Airways New Zealand submission to the Civil Aviation Authority's 2017 Taranaki Airspace Review

**Prepared by: John Wagtendonk
Policy, Standards and Safety Improvement**

Updated version 4 25 March 2017

This submission requests a reduction in the size of the New Plymouth control zone (NP CTR) and significant changes to the New Plymouth control area (NP CTA). Associated with the NP CTA change, the Auckland CTA/D 6500 ft to 9500 ft (NZA438) and the Christchurch CTA/D 6500 ft to 9500 ft (NZA349) would need to be expanded to the west to match the requested expansion of the NP CTA and provide containment of instrument flight procedures. Other AA CTAs above would also need boundary changes to match the expanded NP CTA.

Diagram 1 Draft NP CTR

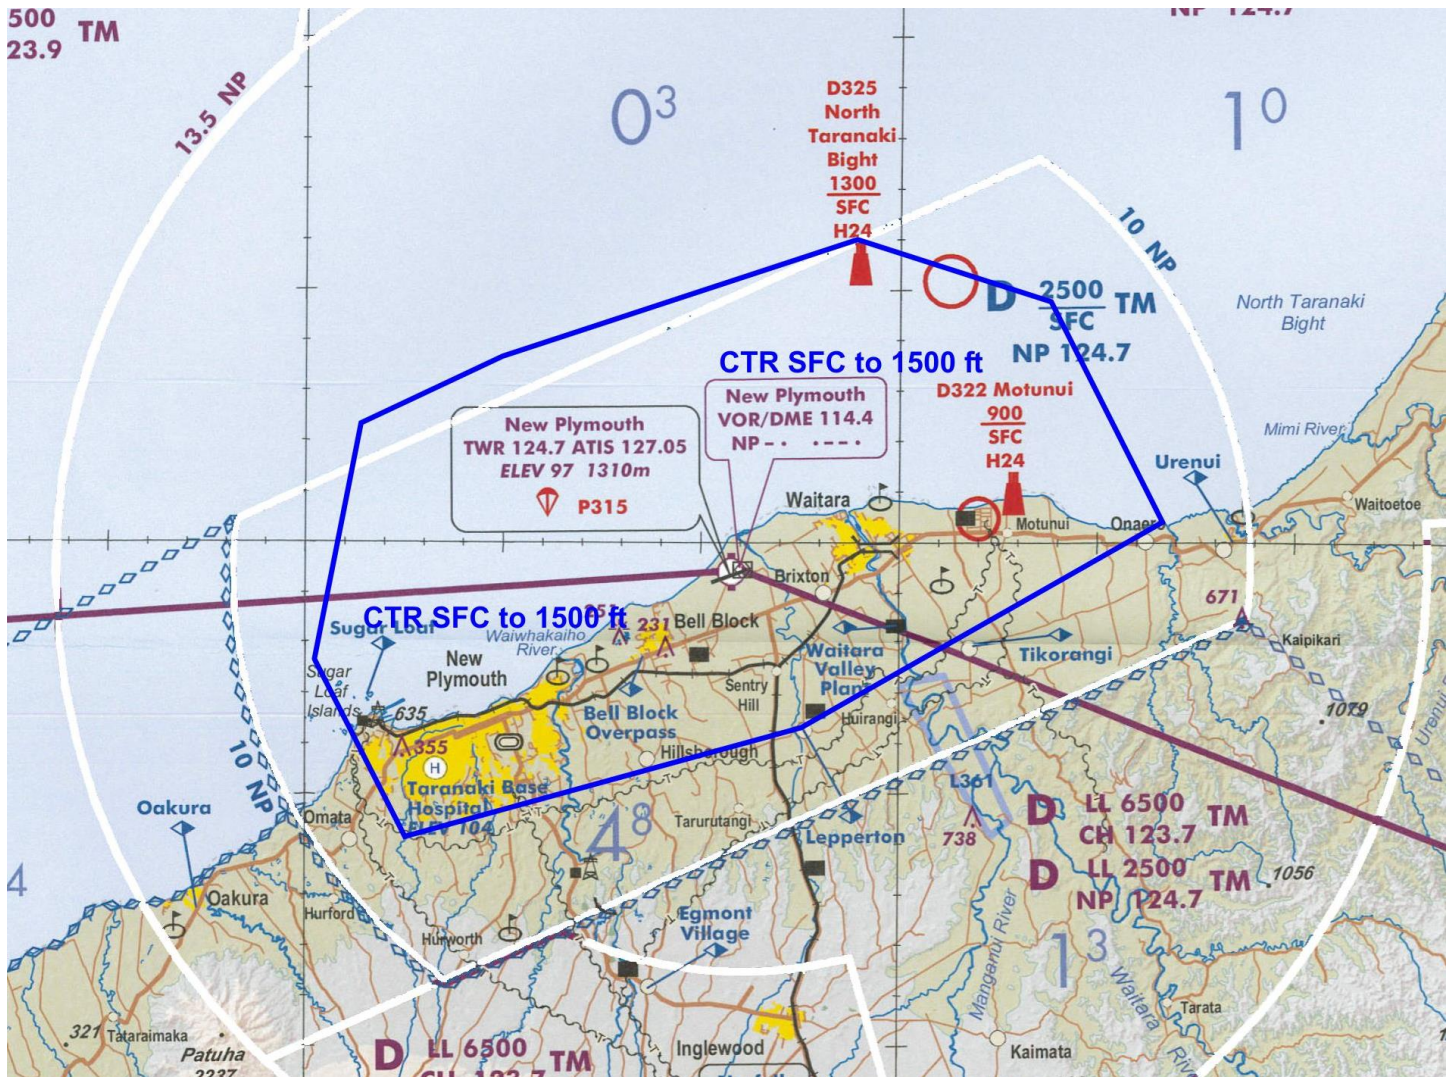
The DRAFT NP CTR proposal as at 3 February 2017 (unchanged with version 3) is depicted in the diagram below. Blue lines are the proposed CTR and the white lines are the existing airspace boundaries to be deleted.

A primary reason for reducing the size of the NP CTR is to reclassify as Class G the airspace that is not currently needed for air traffic control purposes or for containment of instrument flight procedures.

1. The upper limit of the CTR is lowered from existing 2500 ft to 1500 ft.
2. The CTR boundaries are designed to contain the existing VOR/DME approaches based on the aircraft flying a continuous descent profile, including during the base turn, of not shallower than 300 ft per NM to runway threshold/elevation. This is based on AIPNZ ENR 1.5 – 2 para 1.3.3
3. The expanded northern boundary of the draft CTR contains the right-turning VOR/DME RWY 23 missed approach track based on a 300 ft per NM gradient from the VOR at 450 ft MDA. This is based on AIPNZ ENR 1.5 – 2 para 1.3.9. A 2.5 NM buffer from the nominal missed approach track is applied.

4. The CTR provides containment for Cat A and B circling. In accordance with airspace design policy, containment of Cat C circling is not necessary as straight-in approaches are available. However, for other design reasons, the Cat C circling area to the north of NP is contained (but not to the south). If this draft CTR does get designated **then an appropriate notation should be made on approach charts regarding lack of Cat C circling protection to the south of New Plymouth.**

5. As well as new PBN straight ahead SIDs, the draft CTR provides for containment of PBN SIDs that turn north/seaward by 30 degrees after take off. A 2 NM buffer is provided between the draft CTR boundary and the nominal track of the RNAV departures to the point where the departure passes 2,000 ft climbing at 300 ft per NM.

6. The draft CTR provides for containment of departures utilising the evaluated climb sector chart (AIPNZ NZNP AD 2 – 62.1) **provided that the chart/departure is amended to specify “minimum turn altitude 1100 ft”** (Current requirement is minimum turn altitude 500 ft)

7. Airspace containment for the NP VOR RWY 05 and NP VOR RWY 23 approaches (the non-DME approaches) is not assured. Most of the approach would be within the draft CTR and CTA but portions of the approach may not be depending on how far outbound the aircraft tracks. **It is suggested that the approaches are annotated along the lines of “Airspace containment not assured for base turn.”**

Diagram 2 Draft NP CTA version 3

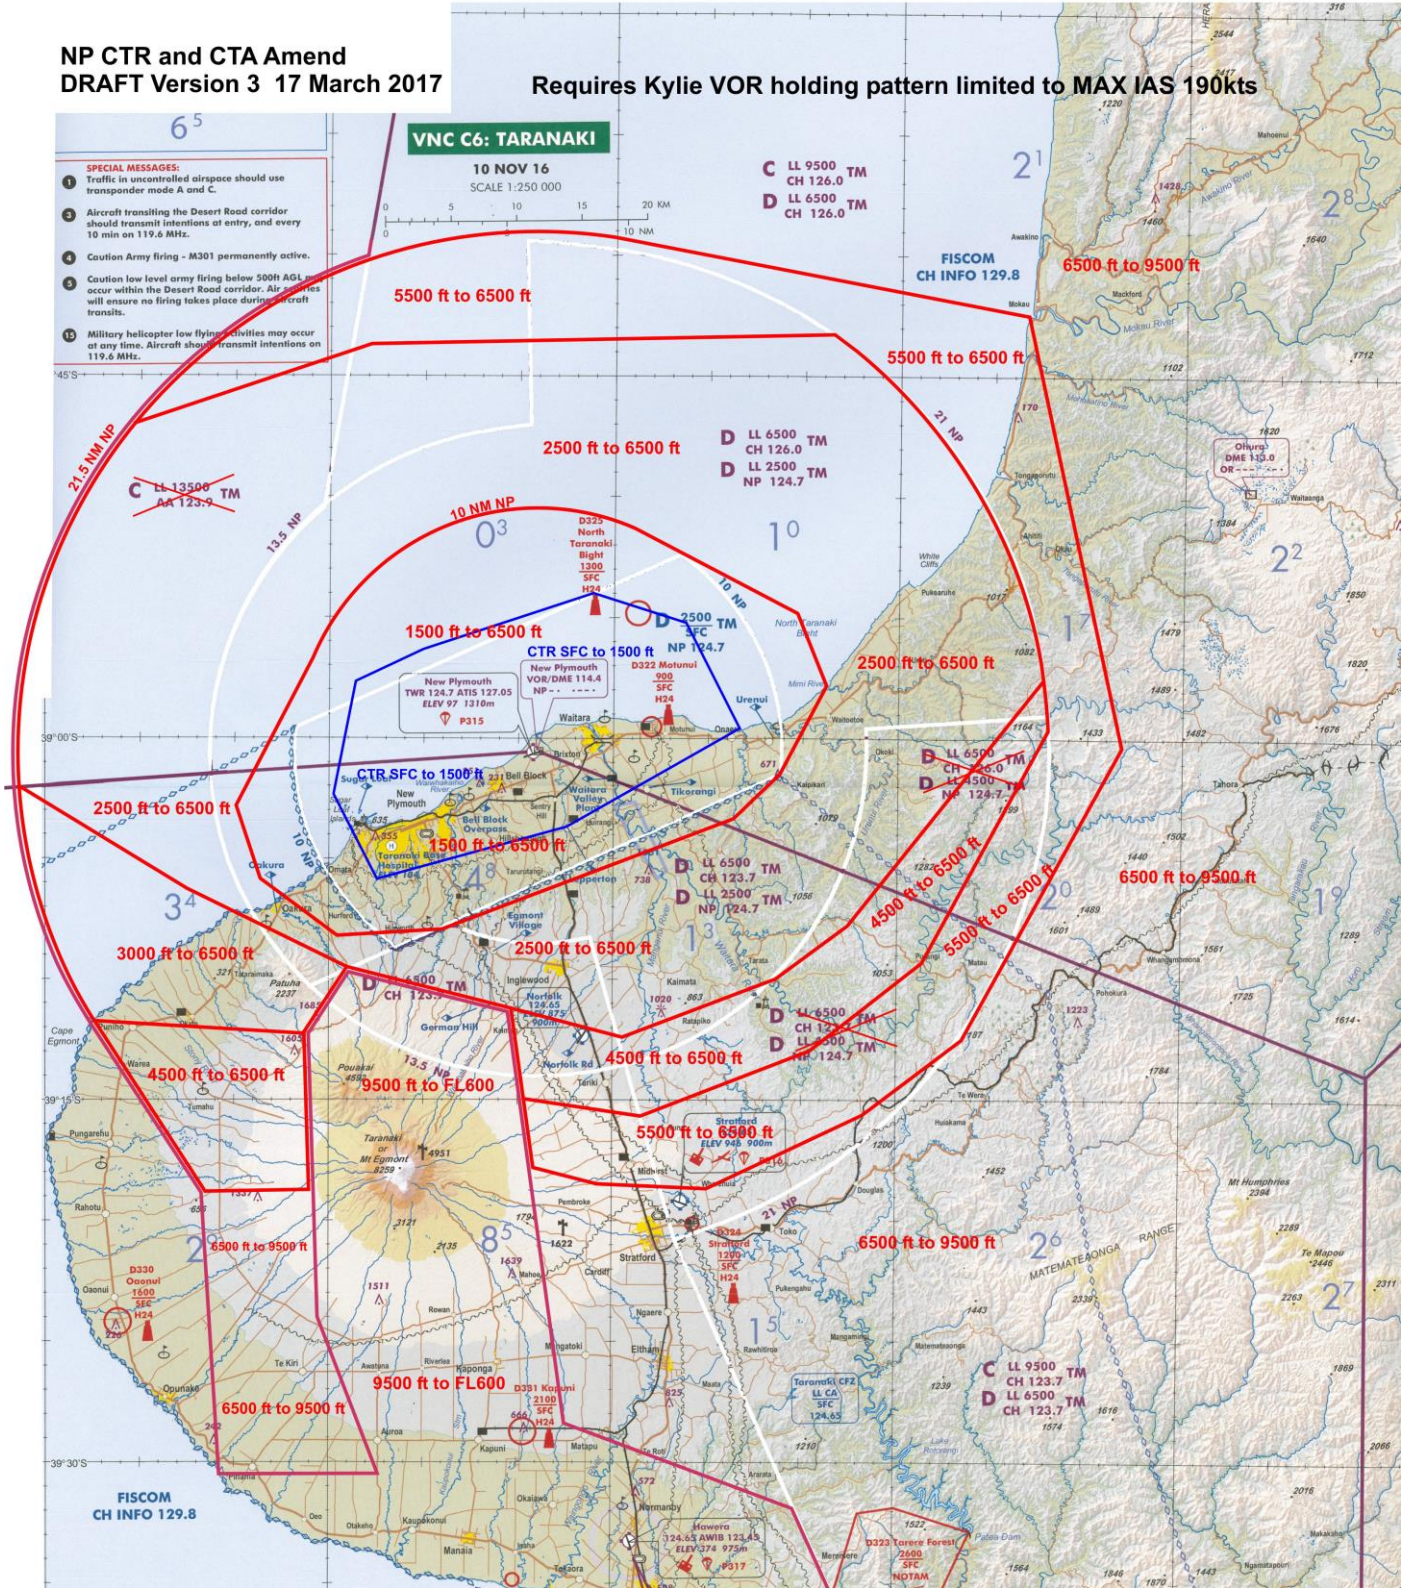
Below is the Airways proposed new NP CTA draft as at 17 March 2017. Red lines are the proposed CTA boundaries and the white lines are the existing airspace boundaries to be deleted.

Requires Kylie VOR holding pattern limited to MAX IAS 190kts

1. The CTA boundaries are designed to contain the planned new NP PBN SIDs and STARs that are being developed. A minimum of 2 NM buffer between the nominal track of the SID/STAR and the CTA boundary is applied. The CTA steps are based on a continuous 300 ft per NM climb/descent gradient from RWY threshold and elevation – except that the 5500 ft to 6500 ft CTA just north of Stratford is based on the 6000 ft altitude restriction in place on IFR departures through new waypoint EGMON.

2. The CTA is minimised as much as practical to fit around the PBN SIDs and STARs and this does lead to the ‘strange’ shapes of the various CTA portions. Where felt appropriate, the CTA boundaries have been moved out a little to nearby geographical features but in many places there is no obvious feature available unless significantly adding to the CTA. Airways welcomes any input from operators as to how the boundaries could be made more ‘user friendly’ whilst still providing the required containment of the IFR procedures.

3. Lowering the upper limit of the CTR to 1500 ft results in the need to add the new CTA portion around NZNP with LL 1500 ft.
4. The extensive CTA LL 2500 ft is needed to provide containment of the holding patterns down to 3000 ft at *ILAND* (new PBN waypoint), *MIMIR* (new PBN waypoint) and *KYLIE* (*see note below*) as well as the two holding patterns for the NP VOR. The *SUGAR* (new PBN waypoint) hold is contained down to 4000 ft. (It is intended that descent below 4000 ft would be permitted once established inbound to *SUGAR* to leave the holding pattern.)

Note: For containment in this draft CTA the *KYLIE* holding pattern needs to be limited to MAX IAS 190 kts.

5. The CTA LL 2500 ft is expanded to the south of NZNP closer to the mountain to contain the PBN arrivals to RWY 05 and the departures from RWY 23. Refer diagrams 3 and 4.
6. The added CTA LL 3000 ft, LL 4500 ft and LL 6500 ft to the west of the mountain is needed to contain the PBN arrivals and departures that track around the west of the mountain. Refer diagrams 4 and 5.
7. As previously mentioned, the Auckland CTA LL 6500 ft and the Christchurch CTA LL 6500 ft both need to be expanded westward of NZNP to match the expanded CTA below. The CTAs above will also need boundary changes to match (NZA147 AA CTA/C 9500 ft to FL600 and NZA149 AA CTA/C 13500 ft to FL600)
8. The IFR arrival and departures via *MANGA* to the south of NZNP are not contained outside 16 NM at 5000 ft as these tracks are used by operators intending to go outside controlled airspace to Hawera.

9. The draft control zone will contain departures using the evaluated climb sectors chart (with minimum turn 1100 ft), however, the draft CTA is not designed to fully contain departures on all 360 radials.

The draft CTA is designed to provide full containment of the VOR radials approximately 340 out to 30 NM clockwise to 150. Radials west of those may not be contained depending on distance and climb gradient. *(Note: some further work would need to be done to determine exactly which radials would be contained.)*

The existing South Three departure will not be contained by the draft NP CTA **therefore this departure either needs to be withdrawn or, if it is desired to be retained, annotated as not being contained by controlled airspace.**

10. Airways does have some concern about the added complexity of the added 5500 ft CTA step but will leave it to CAA and interested parties to consider. If it is considered to be too complex or not practical, the 5500 ft CTA step could be lowered back to 4500 ft.

Diagram 3 Draft PBN STARs to RWY 05 and Draft NP CTA

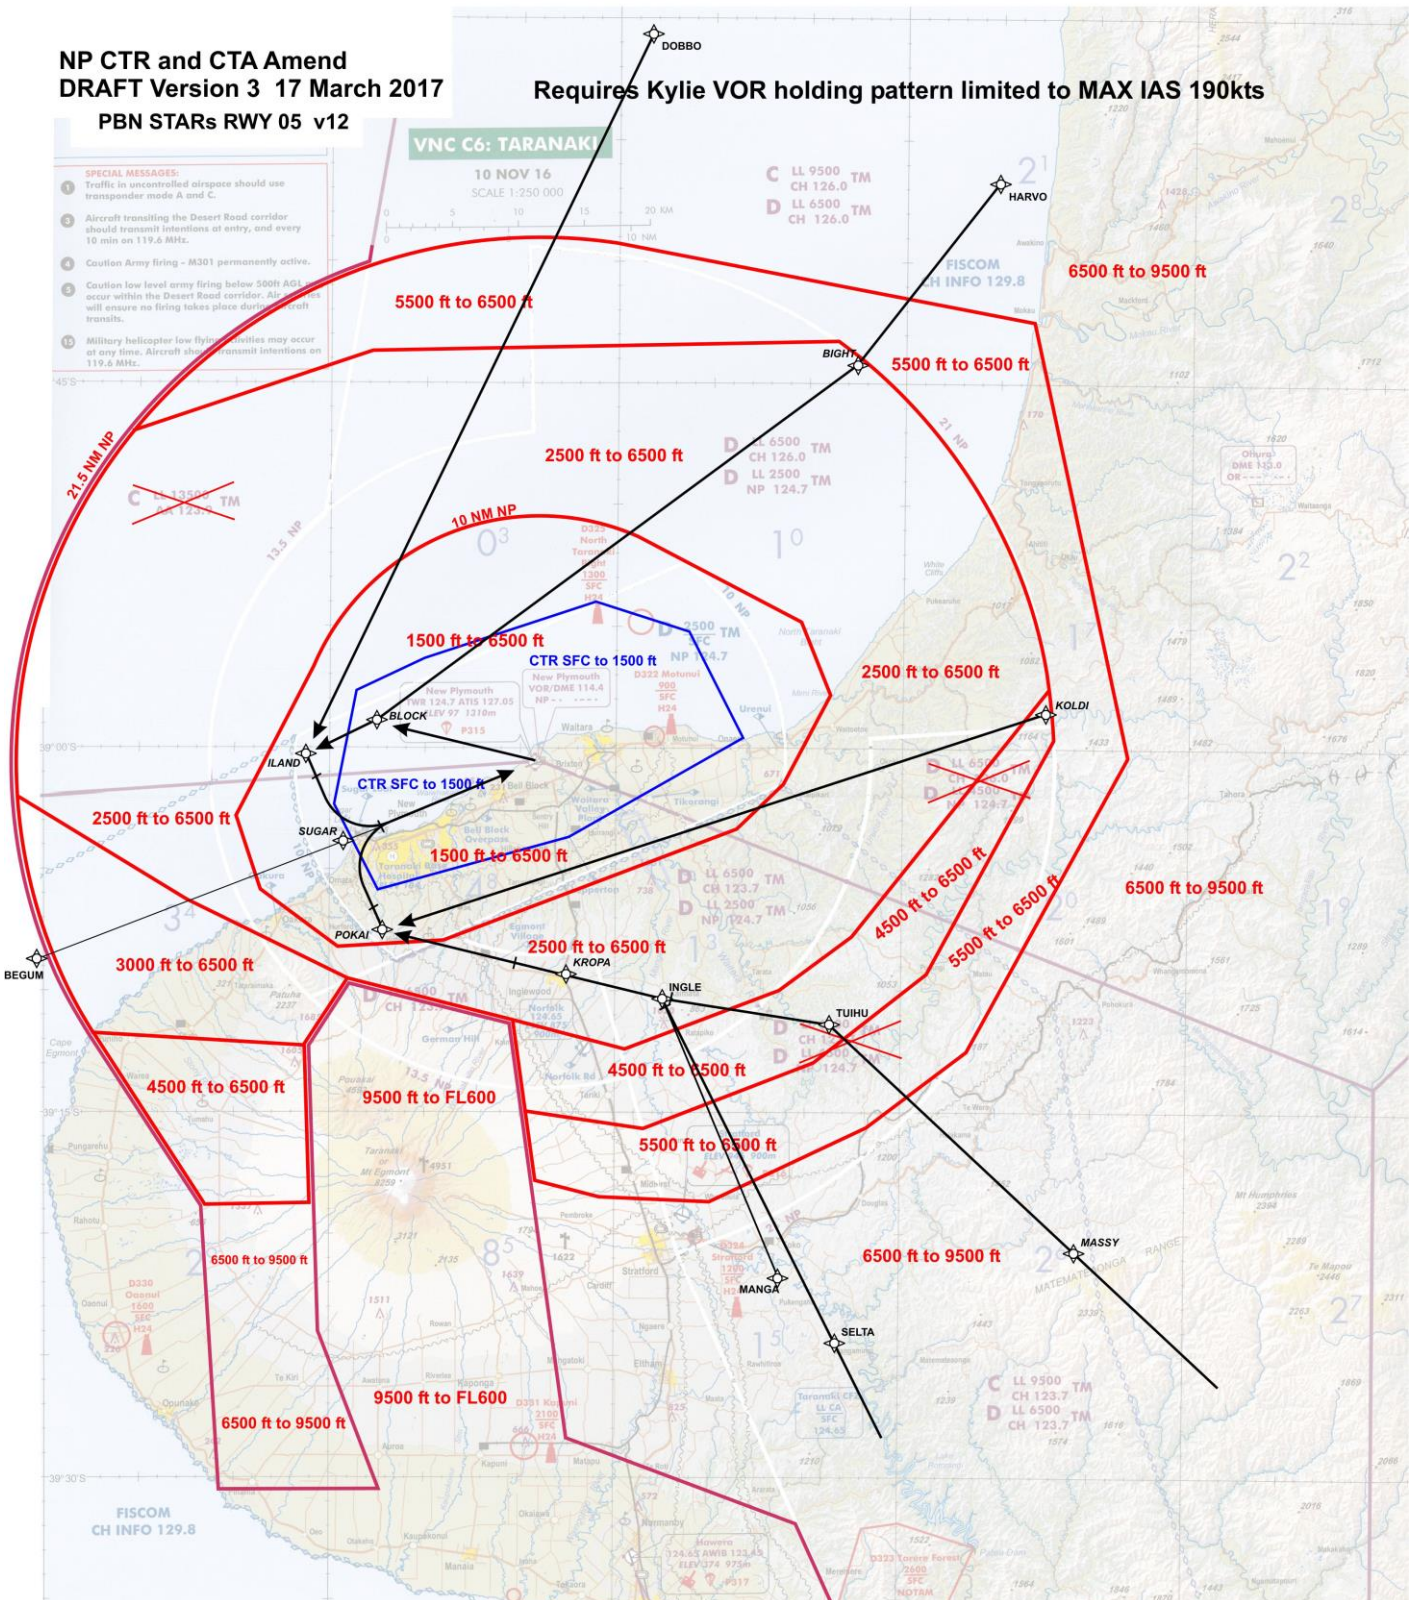
Requires Kylie VOR holding pattern limited to MAX IAS 190kts

Diagram 4 Draft PBN SIDs from RWY 23 and Draft NP CTA

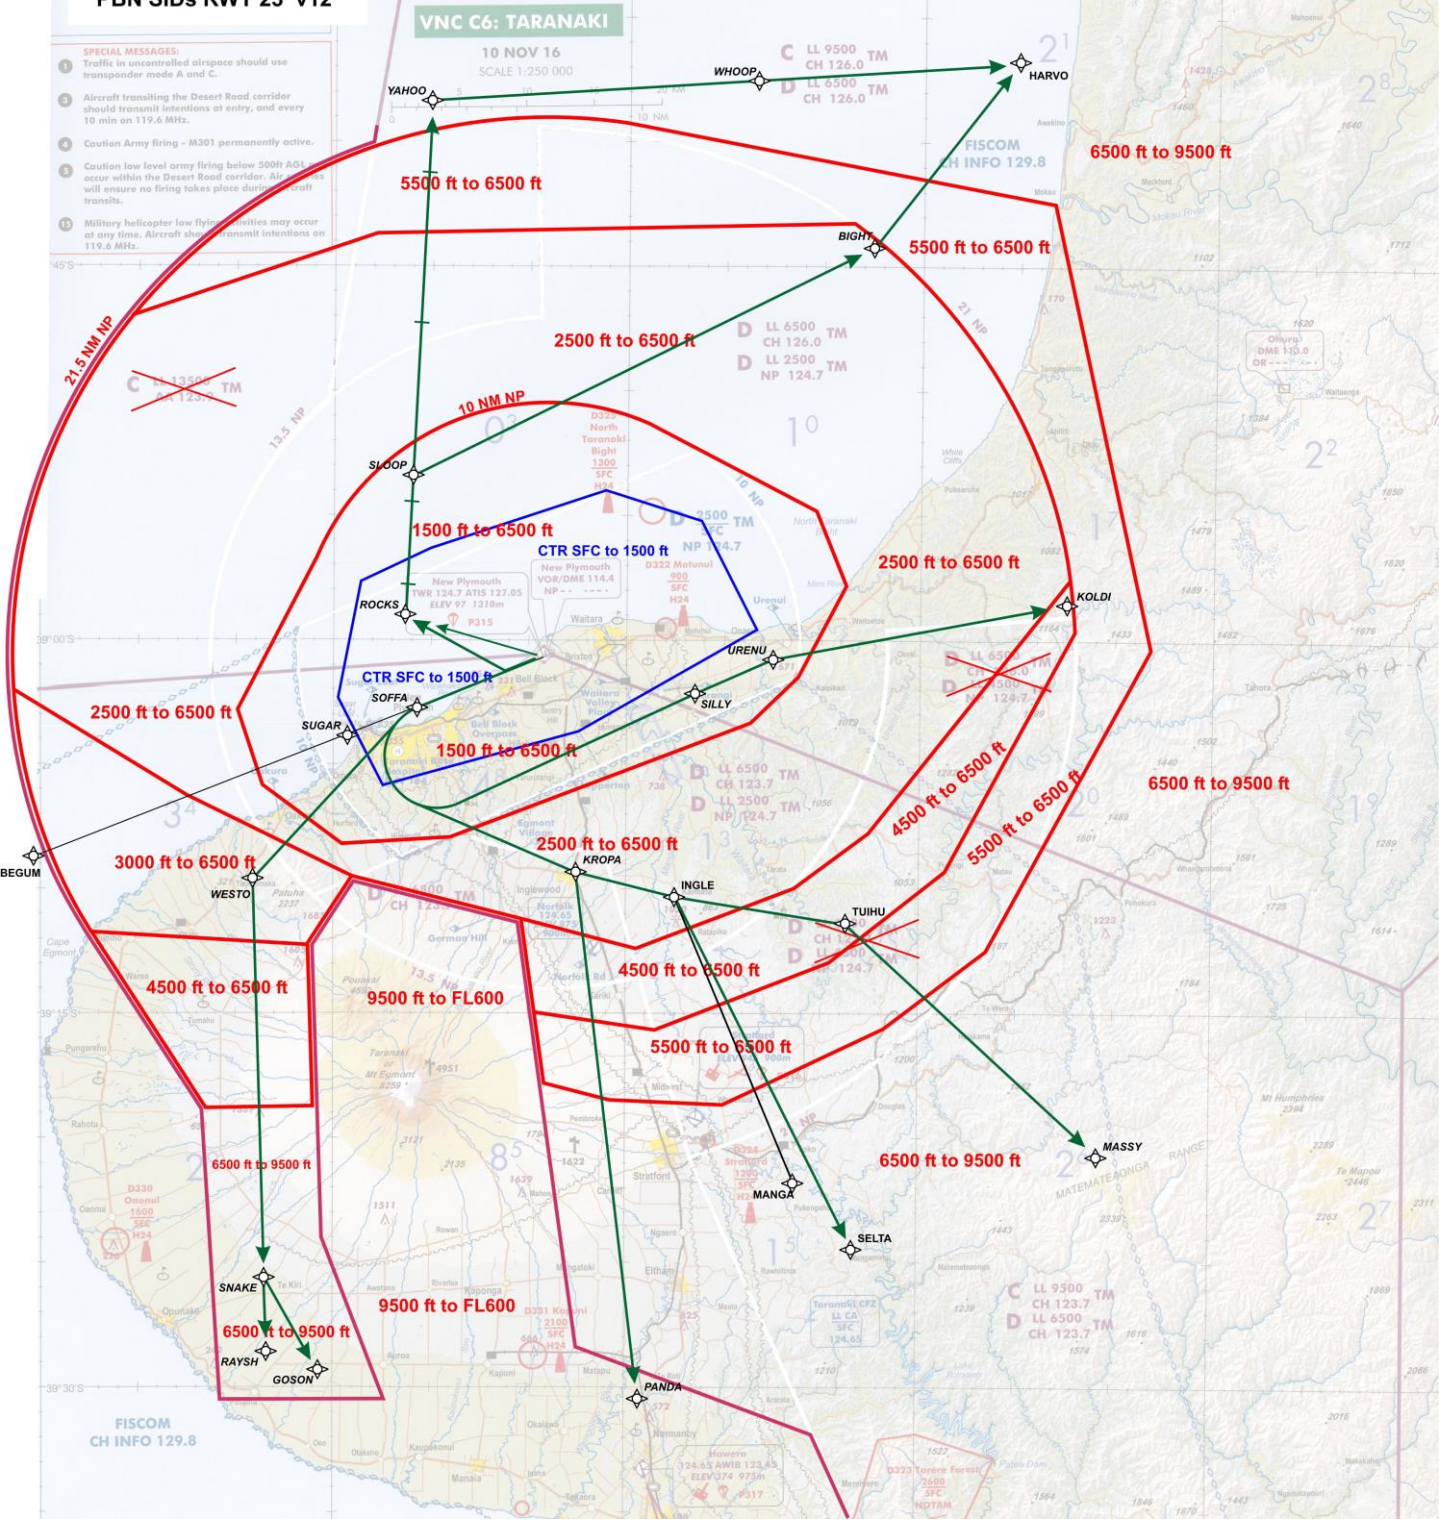
Requires Kylie VOR holding pattern limited to MAX IAS 190kts
